From: Andrew Lonneman <andrew.lonneman@enbridge.com>
Sent: Friday, December 12, 2025 6:06 PM
To: Ram Nunna
Cc: Timothy Isaacson; Mike Cobb; Michael North II
Subject: RE: ENBRIDGE PA500010635 - AUG-US33-WILLIPIE ST INFIELD TP
Attachments: 2025-11-03_122890_AUG-33_Stage3_Submitted-Utility Coordination.pdf; 122890_Gasline.pdf; EGO PA500010635 Approval - No Conflict.pdf

Project: AUG-US33-WILLIPIE ST INFIELD TP – 500010635-0001, WAPAKONETA CITY,
Auglaize County

After a review of the plans for the above referenced project as provided by your office on 11/07/2025, Enbridge does not see a conflict with the plans and the Enbridge 4" Steel High Pressure pipeline as submitted. Please note that Enbridge does have facilities within the scope of the project area. You are required to contact OHIO811.org Call Before You Dig (1-800-362-2764) or 811, prior to your excavation or hand digging and submit an excavation ticket.

GAS LINE

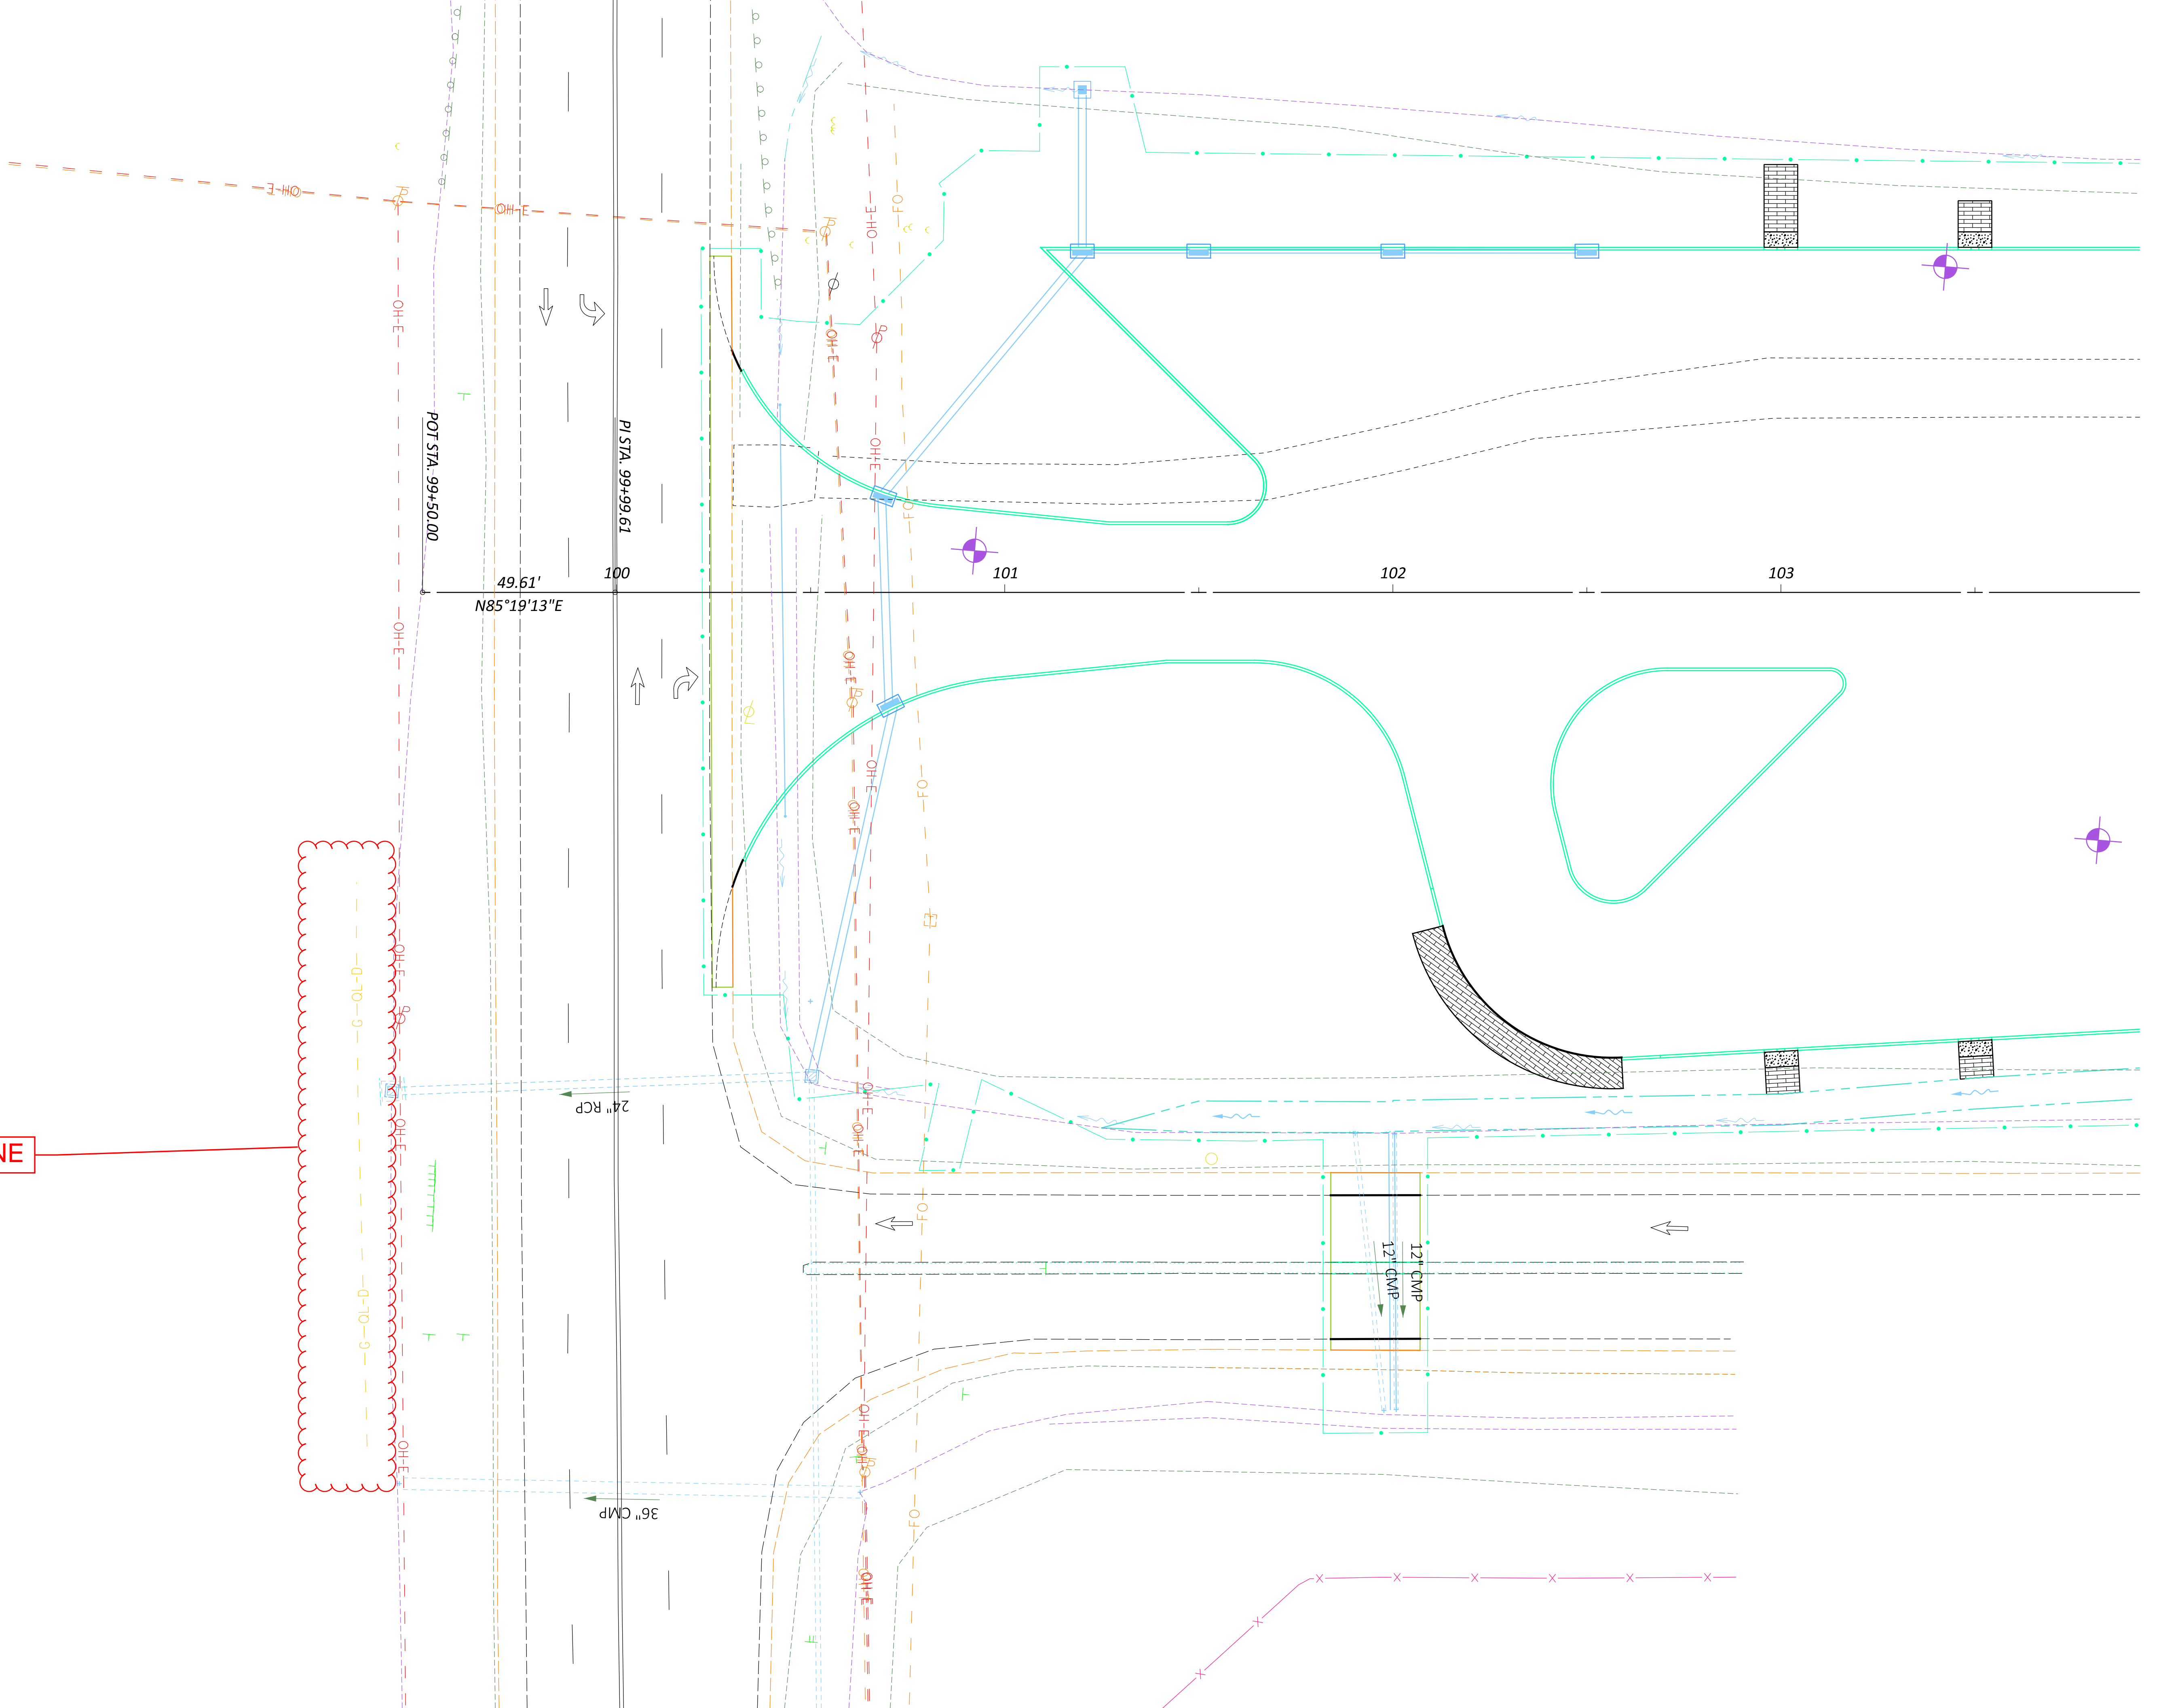
Thanks for calling me this afternoon – per our discussion see the attached pdf. The Sign S-11 (As shown on page 54 of 66 on the Utility Plans set will not impact the gas line. The gas line is further to the west of the sign.

Survey only picked up portion of the gas line as shown on the attached pdf – per our discussion the gas line runs north-south.

Please review and respond – my initial evaluation is your facility is not impacted by the construction of the truck parking project.

Thank you for providing the attached map clarifying the location of the 4" Steel High Pressure Enbridge Gas Ohio pipeline. This is the only known pipeline Enbridge has in the vicinity of your project location, and it is not in conflict with the work provided in the AUG-US33/WILLIPIE ST INFIELD TP ODOT Plan Set.
